Comment O9.1: This comment states that upon review of the Draft EIR, it is clear that the Project would pose serious unmitigated risks to the environmental integrity, public health, housing equity, and the Draft EIR fails to meaningfully address critical issues, and that the Project is flawed and insufficiently mitigated.

Comment O9.2: This comment states that the mitigation measures included within impacts AQ-1 and AQ-2 are unenforceable and ineffective. The comment states that mitigation requiring the installation of electric vehicle charging infrastructure with no requirement for use is inadequate. The comment states that the Draft EIR fails to provide enforceable, measurable, and effective mitigation as detailed in CEQA Guidelines Section 15126.4.

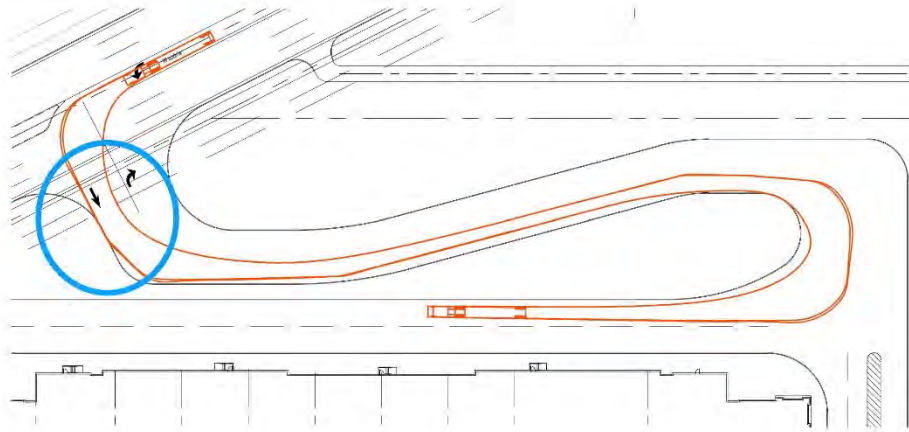
The same is true for the truck entering the site via Frontage Road at Building 6, which will overlap on the internal curb, indicating there is not suitable available space to accommodate truck maneuvering. This exhibit also does not depict two trucks simultaneously entering and exiting site and there does not appear to be enough maneuvering space for two trucks given that there is not enough area for a single truck without overlapping on the internal curb. The geometric design of the circulation system and project site will substantially increase hazards and a significant and unavoidable impact exists, which must be disclosed in a revised EIR.

Response O10.1 through O10.32: Please see Responses O4.1 through O4.31 for responses to this comment letter.

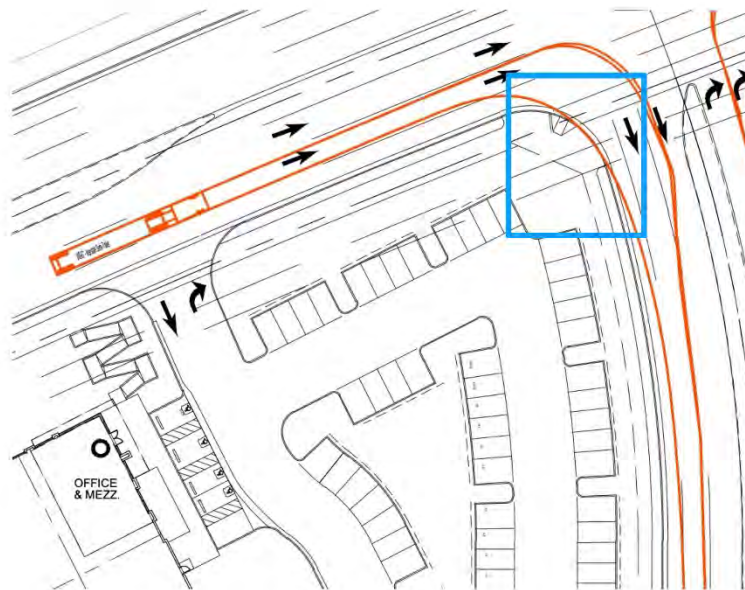
A similar issue exists for the truck entering the site via Frontage Road at Private Drive A between Buildings 2 and 3. This truck will also overlap on the curb, indicating there is not suitable available space to accommodate truck maneuvering. The geometric design of the circulation system and project site will substantially increase hazards and a significant and unavoidable impact exists, which must be disclosed in a revised EIR.

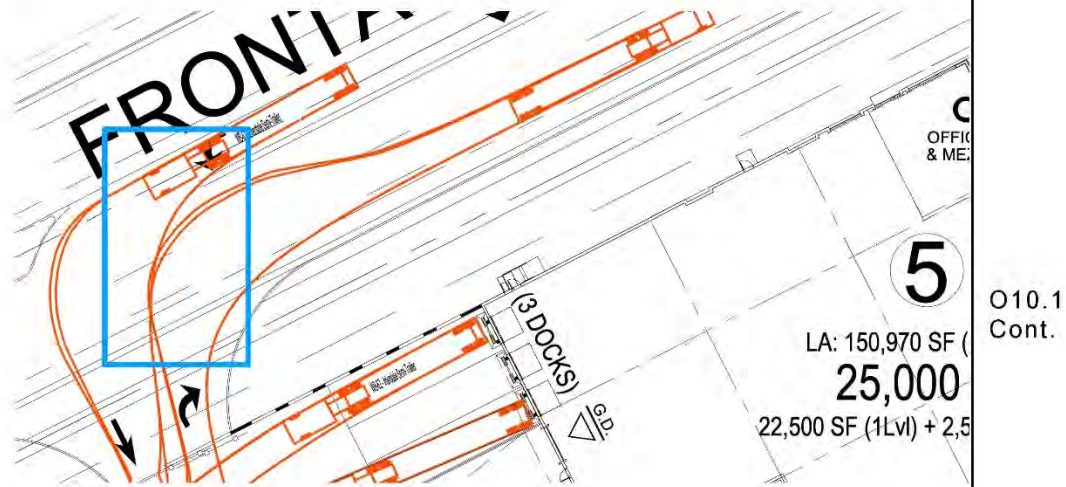
It is particularly notable that the trucks accessing the site via Frontage Road at Building 5 will collide on Frontage Road. The geometric design of the circulation system and project site will substantially increase hazards and a significant and unavoidable impact exists, which must be disclosed in a revised EIR.

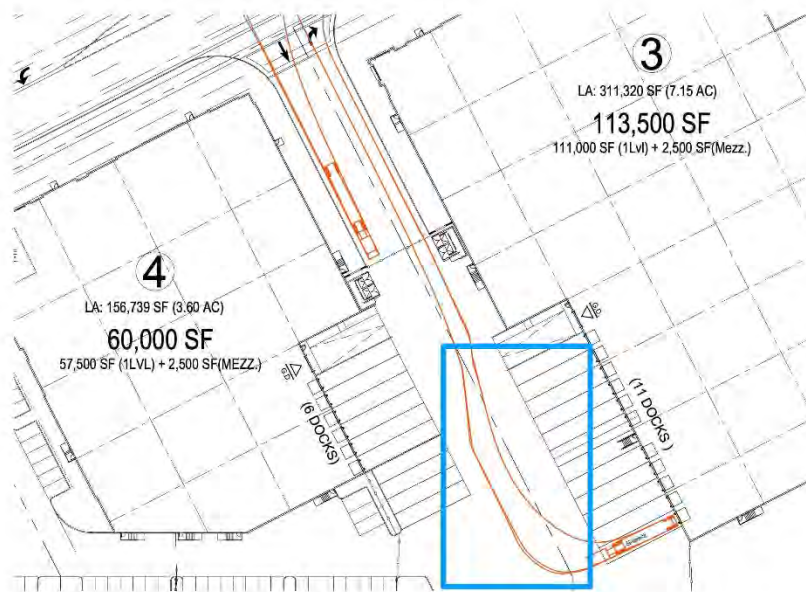
Additionally, trucks accessing the internal truck/trailer loading dock court between Buildings 3 and 4 do not have adequate internal maneuvering space. As shown below, a single truck backing into a loading dock space requires the entire loading dock area to maneuver into the space. There is no other maneuvering area available, meaning that other trucks must queue and wait for the area to clear in order to proceed. Increased queuing results in increased idling (and associated emissions) will require increased internal queuing area in order to avoid queuing on Frontage Road. The geometric design of the circulation system and project site will substantially increase hazards and a significant and unavoidable impact exists, which must be disclosed in a revised EIR.

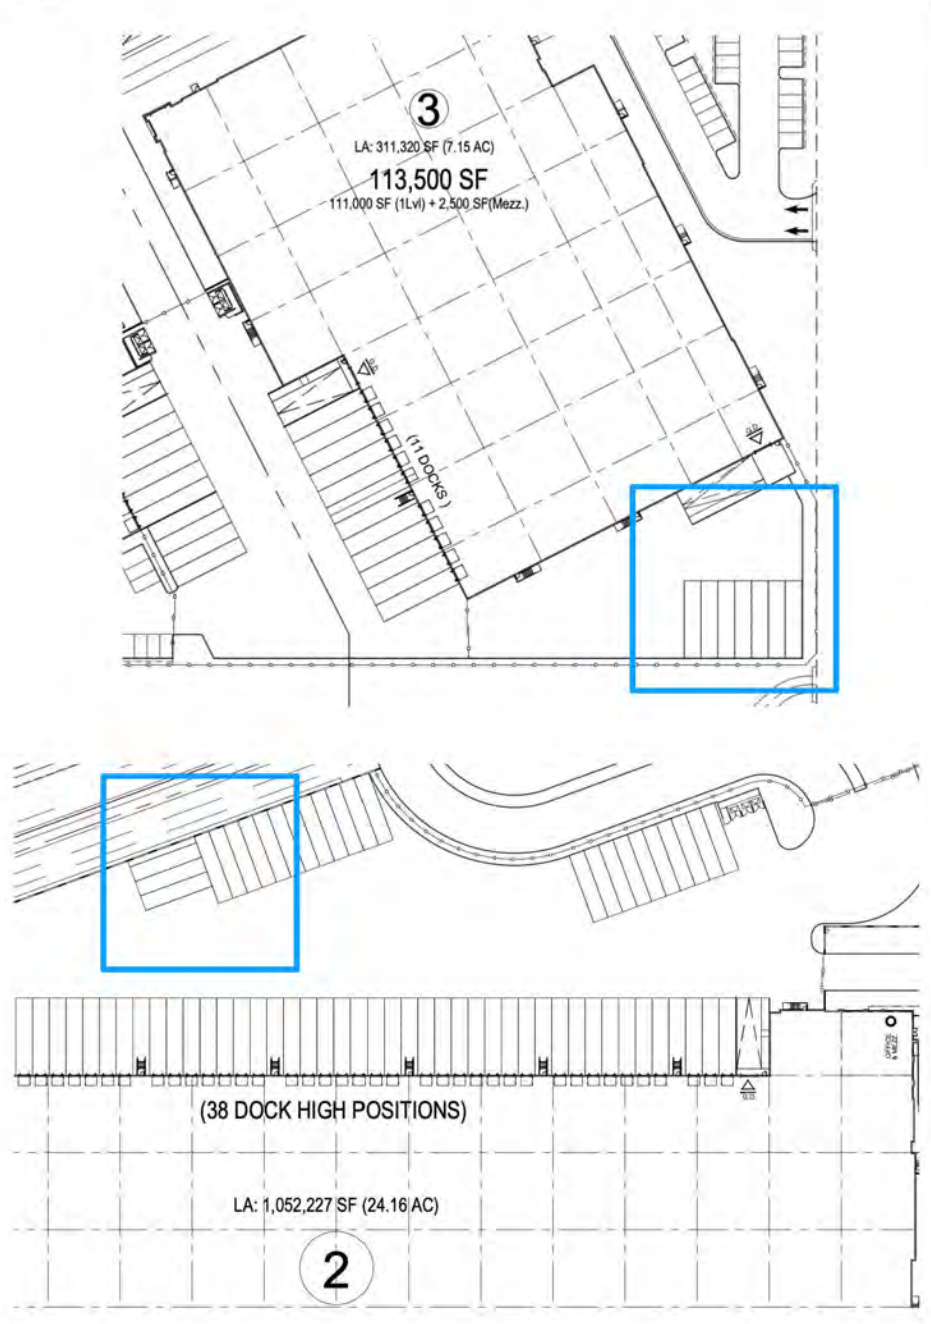
There are no exhibits adequately depicting the onsite turning radius available for trucks maneuvering throughout the parking areas of the site. For example, the truck/trailer parking spaces are located within the truck/trailer loading dock court and some are designed in unconventional configurations that restrict internal maneuvering area, as shown below. These parking stalls that may be in use at any time and further restrict truck/trailer movement, including increasing truck idling as tandem parked trucks require additional time to maneuver, which will also result in increased queuing duration and associated queuing area for trucks/trailer. A revised EIR must be prepared to include a finding of significance due to these significant and unavoidable impacts that have not been analyzed.

Figure 1. Actual and predicted relationships between the numbers of vertebrate wildlife species detected and the elapsed survey time based on Noriko's visual-scan surveys on 18 and 21 July 2025.

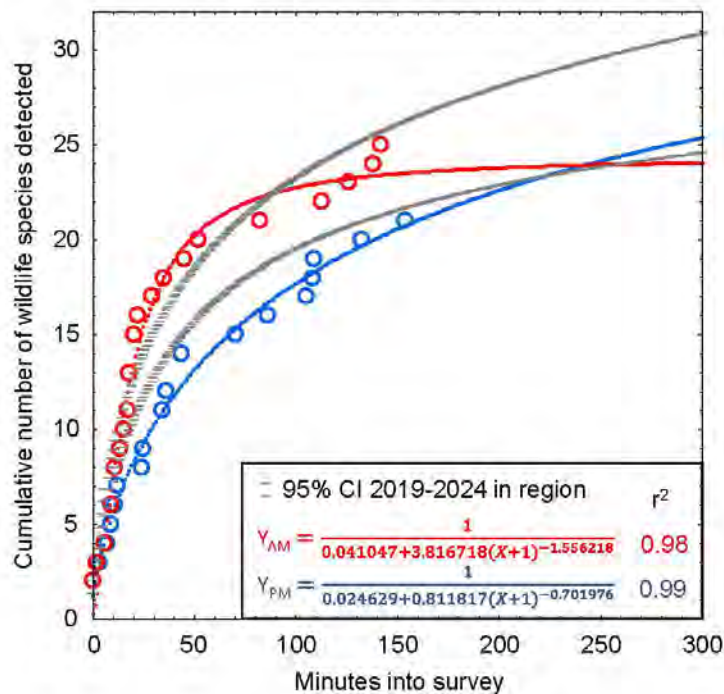
Noriko detected 33 species of vertebrate wildlife, which was a relatively large number for the brevity of her survey effort. However, the species of wildlife Noriko detected at the project site were not the only species that were present during her surveys, as some species typically go undetected. To demonstrate this, I fit nonlinear regression models to Noriko's cumulative numbers of vertebrate species detected with time into her surveys to predict the numbers of species that she would have detected with longer surveys or perhaps with additional biologists available to assist her. The model is a logistic growth model which reaches an asymptote that corresponds with the theoretical maximum number of vertebrate wildlife species that could have been detected during the survey. The model fit to Noriko's evening survey data, for example, predicts 41 species of vertebrate wildlife were available to be detected that evening, or twice the number of species she detected that evening (Figure 1). Her rate of species detections during the morning survey followed and even exceeded the upper bound of the 95% confidence interval I estimated from other morning surveys in the region (Figure 1).

Response O10.6: The Project site's environmental conditions are not comparable to the conditions that the commenter describes for the Altamont Pass Wind Resource Area. The Project site is surrounded by urban development on all sides including I-215 to the west, retail and residential uses to the south, commercial and residential uses to the east, and public and industrial uses to the north. The Altamont Pass Wind Resource Area is located in a rural area of Northern California. Therefore, the two locations are not comparable for purposes of onsite biological habitat. Furthermore, biological analysis under CEQA does not rely on modeling for an estimate of how many species could occur onsite, but on the review of existing databases and field surveys.

Figure 2. Actual and predicted relationships between the numbers of bat species detected and the elapsed survey time based on Noriko’s nocturnal survey on 18 July 2025.

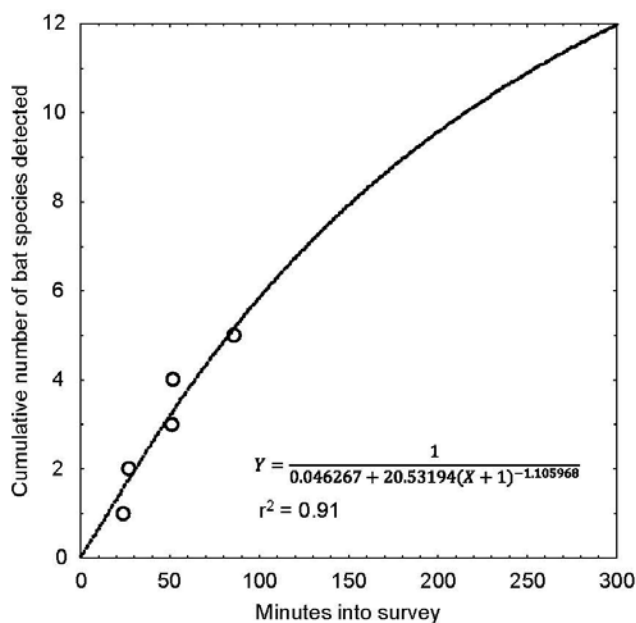
The same type of model fit very well to Noriko’s cumulative number bat species detections with increasing time into her nocturnal survey (Figure 2). The model predicts that had she continued her survey for five hours, she would have detected 12 species of bats.

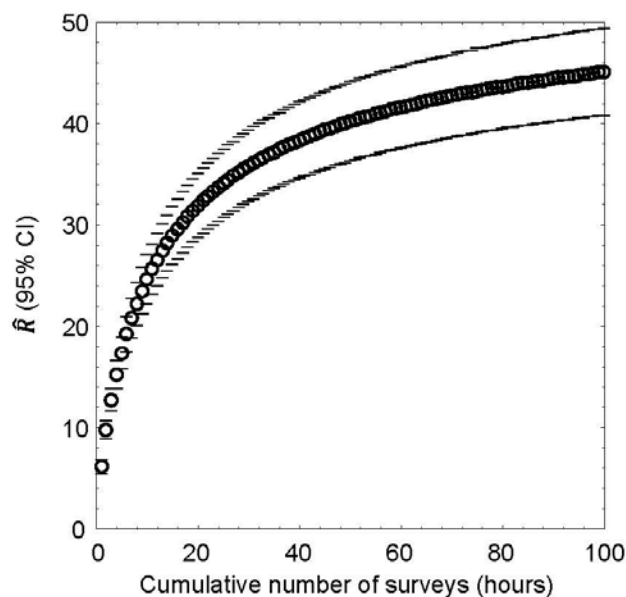
Because my prediction of 86 species of vertebrate wildlife, including 21 special-status species, is derived from daytime visual-scan surveys, and would detect few nocturnal mammals such as bats, the true number of species composing the wildlife community of the site must be larger. Noriko's reconnaissance surveys should serve only as a starting point toward characterization of the site's wildlife community, but it certainly cannot alone inform of the inventory of species that use the site. More surveys are needed than her two surveys to inventory the project site's wildlife community. Nevertheless, the large number of species I predict at the project site is indicative of a relatively species-rich wildlife community that warrants a serious survey effort. The patterns in the data and what I know of nocturnal species, I predict at least 120 species of vertebrate wildlife rely on the project site as habitat.
